Determination 2017/066

Regarding the refusal to issue a code compliance certificate for a 19-year-old house with mixed claddings at 16 San Lorenzo Rise, Henderson Heights, Auckland

Figure 1: Approximate site plan

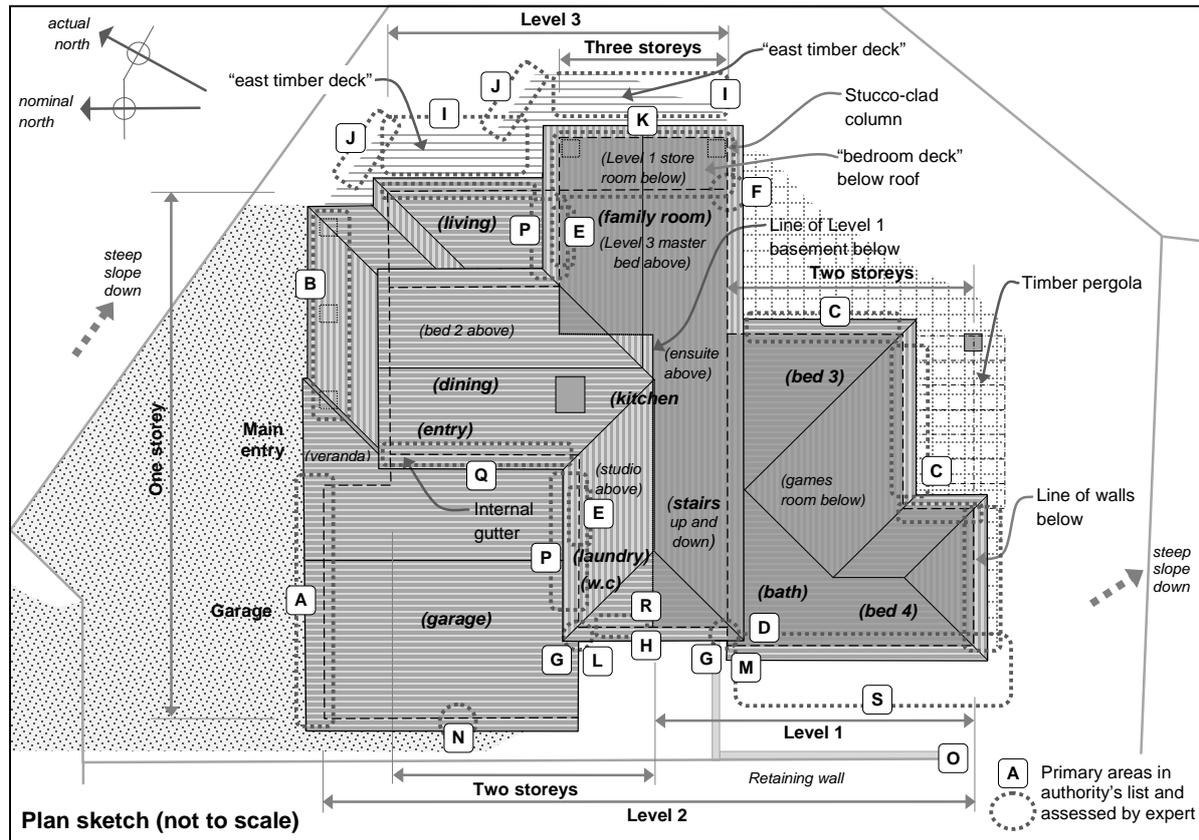
3.2.2 The authority listed items that required attention (“the authority’s list”), which were ‘not limited to’ the following (in summary, with relevant locations in brackets – see Figure 1):

1. Cladding:
 - a) Clearances to brick veneer (Area A,B,C, D)
 - b) Clearances to apron flashings and membrane (Area Q)
 - c) Cracks to stucco
 - d) Damaged cladding at end of west stucco/brick flashing stop end (Area H)

- e) Unsealed plaster to upper west
 - f) Post construction flashings installed (Area H)
 - g) Lack of anti-capillary gap at fascia/wall junction (Area G)

- h) Cladding/joinery junctions (Area E,H,R,)
 - i) Unknown flashings to deck/upstand and roof/wall junctions (Area F)
2. Cracks to interior plasterboard

3. Decks:
 - a) Lack of bracing (Area I)
 - b) Boundary joist and balustrade to timber deck not compliant (Area I,J)
 - c) Deck membrane under floating decking (Area K)

- d) Deteriorating deck joists to timber deck (Area I)
 - e) Deteriorating mechanical deck fixings (Area I)
 - f) Timber deck joist spacing not in accord with drawings (Area I)

- g) Deteriorating timber balustrade (Area J)
4. Drainage:
 - a) Unable to inspect west elevation due to water ponding (Area D, S)
5. Meter box: panels dislodged (Area N)

6. Compliance of new balustrade to bedroom deck (Area K)
7. Plumbing:
 - a) Broken pipe supports (Area L,M)
 - b) Damaged waste pipe to west gulley trap (Area L)

8. Retaining wall: not shown on approved plans (Area O)
 9. Roof:
 - a) Damaged apron flashings and cracked roof tiles (Area P)
 - b) Membrane to internal gutter (Area Q).
- 3.3 It appears that the applicant carried out some further repairs and maintenance to the house then approached a building surveyor about assessing the items in the authority's list. In an email dated 2 November 2016, the building surveyor described destructive testing that would be involved and recommended that a determination be sought to clarify the areas requiring remediation.
- 3.4 The Ministry received an application for a determination on 2 March 2017, which was accepted on 14 March 2017. The Ministry sought further information from the authority, which was received on 22 March 2017. Consent for the expert to undertake invasive testing was not received until 20 April 2017.
